**Addendum # 4
Bid Opportunity: 2019-11977T - Twin Lakes Secondary School-Interior
Renovation-Hospitality
Closing Date: Thursday, March 21, 2019 1:30 PM**

ADDENDUM

NOTE: THIS ADDENDUM DATED 14 MARCH 2019 (4 PAGES TOTAL) SUPERCEDES ADDENDUM NO. 3, DATED 13 MARCH 2019 POSTED ON THE SIMCOE COUNTY DISTRICT SCHOOL BOARD WEBSITE FOR BIDS AND TENDERS.

BASEMENT PLAN – RENOVATION
SCALE: 1:100

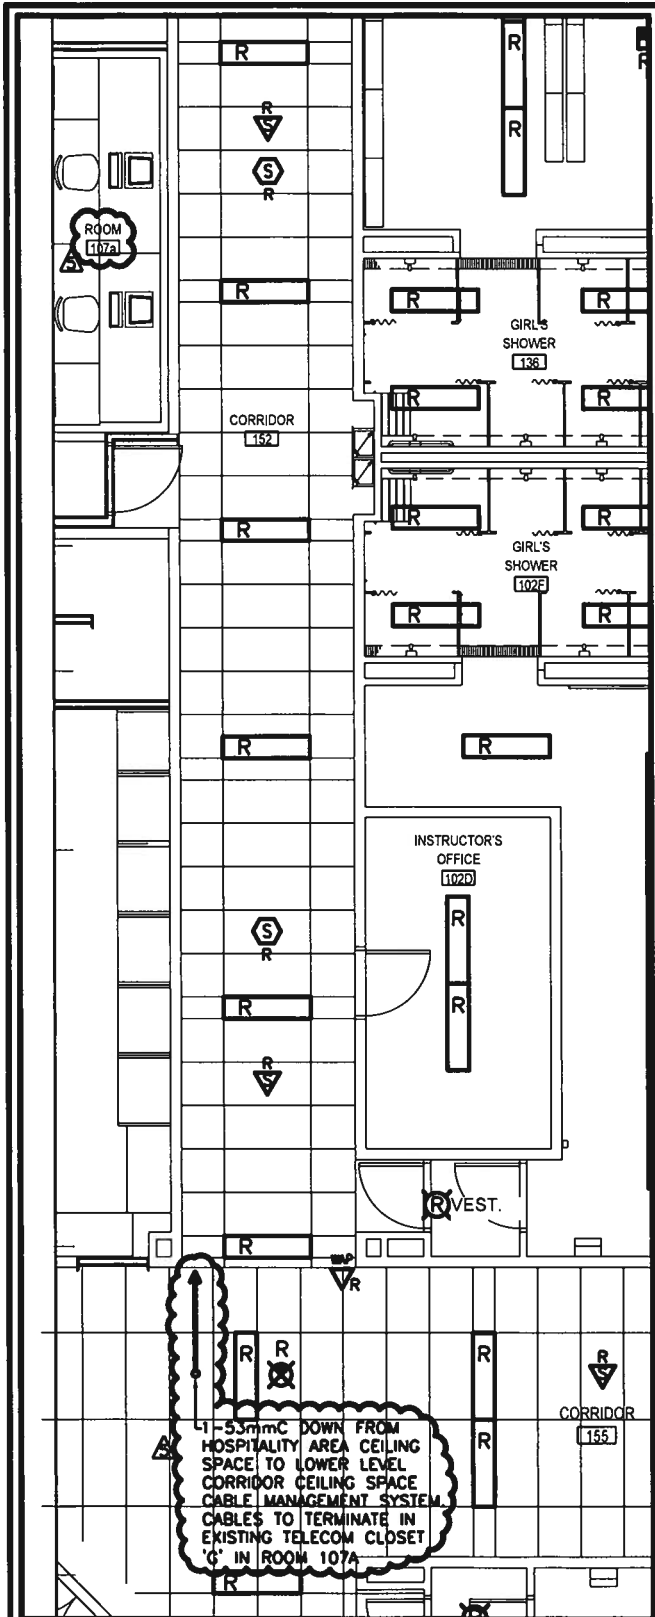
- 2.0 Reference Drawings E04, E-05 and Attached Sketch SKE-5
- .1 On drawing E-04 on the basement renovation plan at existing telecom closet 'G' located in Room 107A, provide new patch panel to suit existing wall bracket and coordinate with School Board for relocation of existing data switch to facilitate new patch panel. Observe labeling standards of horizontal data cabling per specifications. All data communications cabling from the ground floor Hospitality area is to terminate here. On drawing E-05 and sketch SKE-5, provide 1 – 53mm (2") riser conduit between ceiling space of Hospitality Room and ceiling space of lower level corridor over to existing cable management system and up corridor to Telecom Closet 'G' in Room 107A. This contractor to firestop the penetration at 2 hr rated floor/ceiling assembly. All telecom outlets in Hospitality renovation area shall have conduits run in ceiling space to the vicinity of the new riser conduit.
